1505 WILLIAMSBURG
- ADDRESS FILE

Driveway Width

1505 Williamsburg Ave @ The Twin Oaks Subdivision - Proposed Driveway Layout

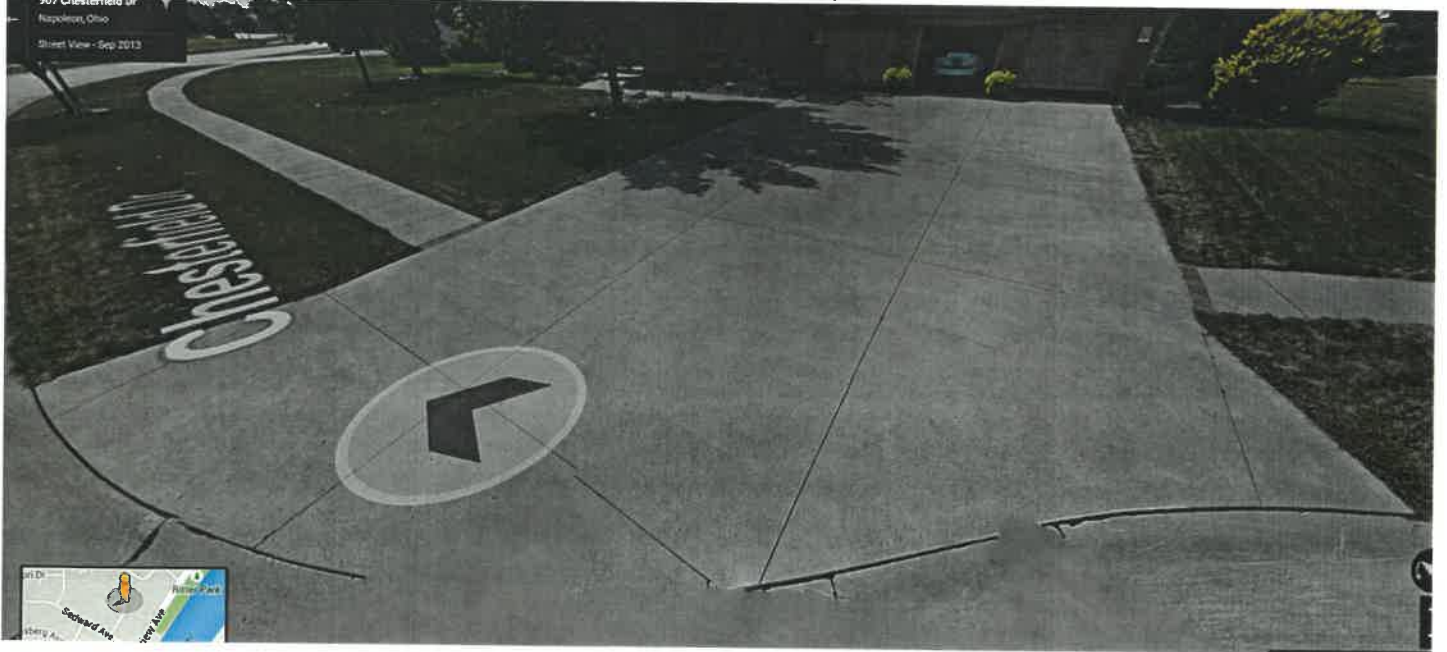
I reviewed your request regarding the extra width for your proposed drive approach. I am not able to allow the full 32' you requested. The standard drive approach dimensions allow a 24' width with 3' wings on each side for a total of 30'. What I can allow would be a 30' wide drive approach with no wings. All of the approach must be constructed in compliance with City specifications. Drive approaches must be a minimum of 6" Class C concrete on 6" of ODOT 304 or ODOT 411. 1" expansion joint must be installed along the back of the curb. The concrete approach must be sawed/jointed with slabs no larger than 12' in any direction. If you use a 30' width, I recommend using 10' square slabs.

At 1505 Williamsburg Ave we would like to install a 32' wide driveway in front of our 3 car garage. While it may be customary in Napoleon to restrict drive width to 24' at curbside, we think that a wider drive could be constructed without deviating from the standards of the Twin Oaks subdivision. This would provide more area for parking for our guests and allow for an easier approach to our third garage bay. At the 32' width, flares at the curbside should not be required.

The right-of-way should be 1' behind your sidewalk, but if you want to start your flare at the sidewalk that will be fine. Tom was correct about the sidewalk thickness. The standard walk needs to be 4' wide. Also, it is 4" of concrete on 4" of ODOT 411. The first 5' from both sides of the drive need to be 6" of concrete on 6" of ODOT 411. This insures that it won't break if someone mistakenly drives on it.
